## Crosswalks in Kincardine

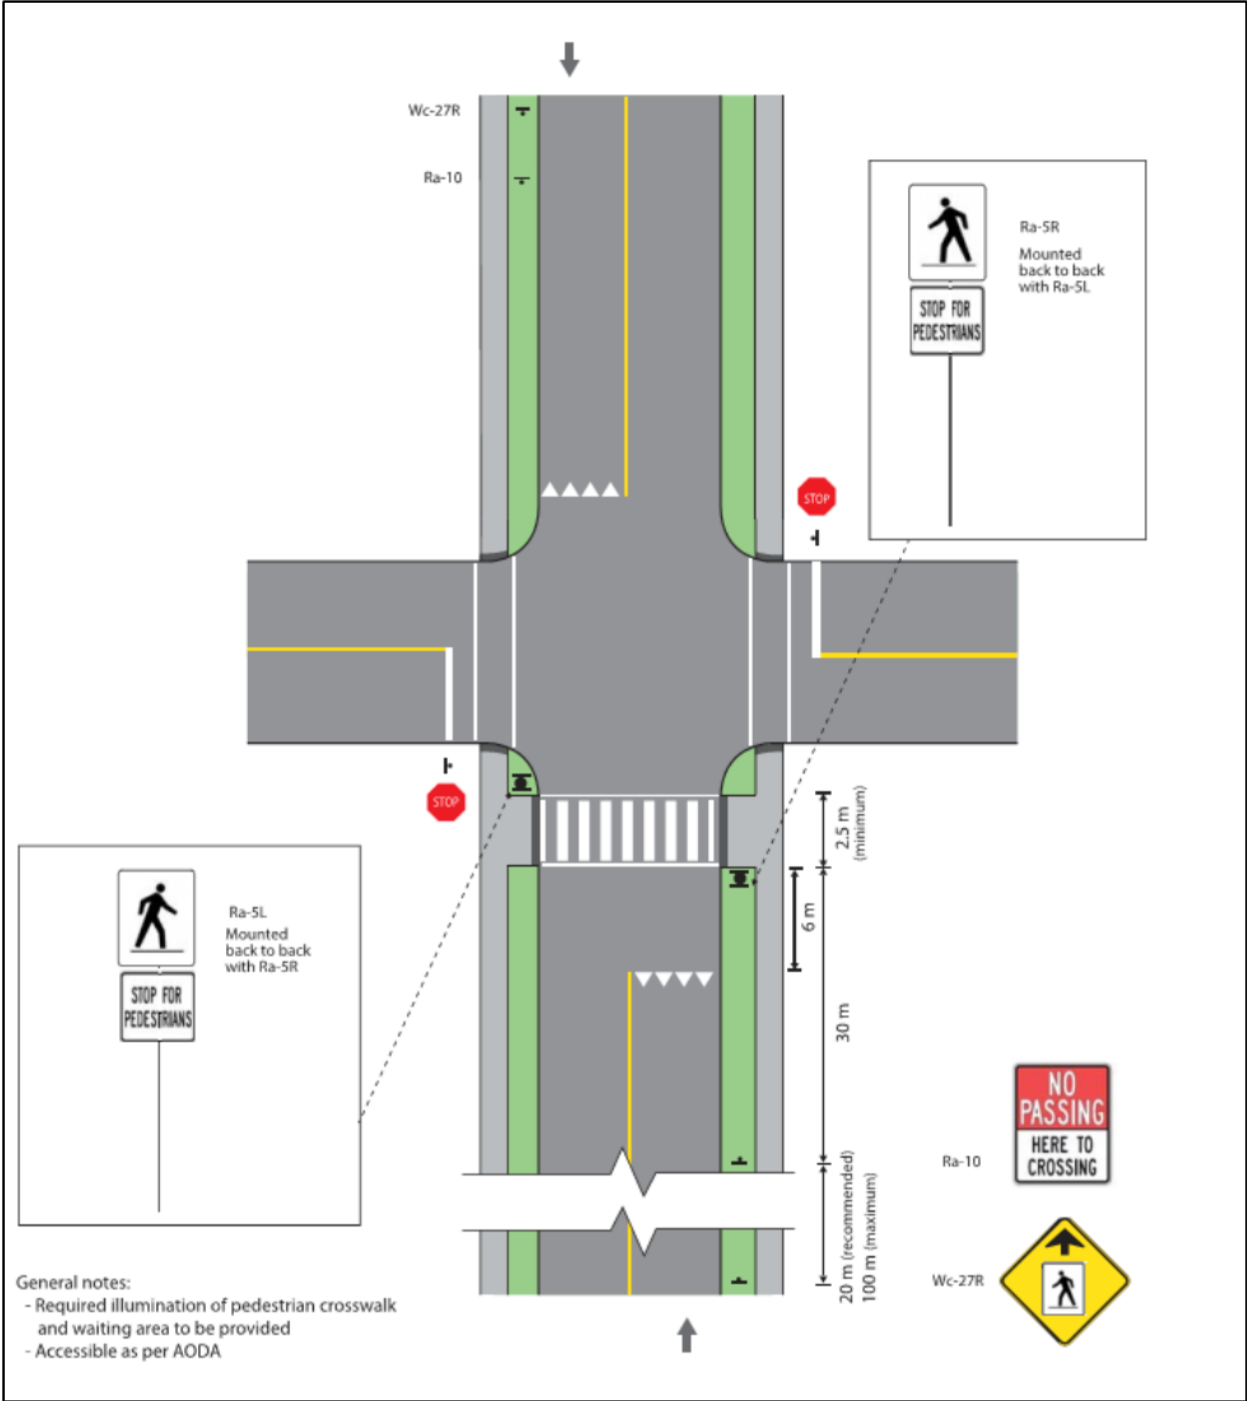
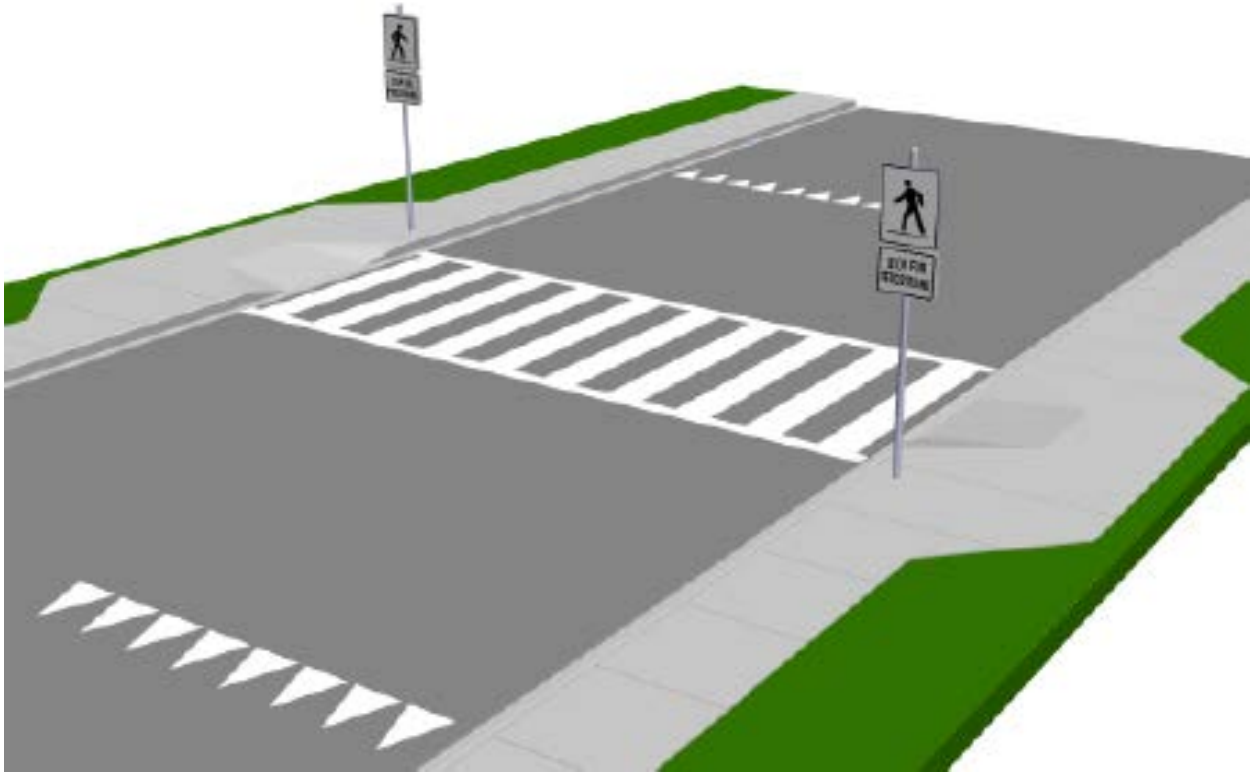
This crosswalk is at station beach It to does not meet the AODA It does not have the audible

This is the one that Bruce Power installed at the No frills corner It to does not have the audible

Tactile plates should be added to the sidewalk on either side of the PXO's to meet accessibility standards. I can confirm this exists at Princes; and does on the one side of Park. Corey, can you have one installed on the north side if it is nonexistent, please.

Regarding the information below, that is for a signal and not a PXO as described above. Tracey, feel free to share this with the committee in an effort to educate the group so they can understand that no mistake was made here. Thanks.
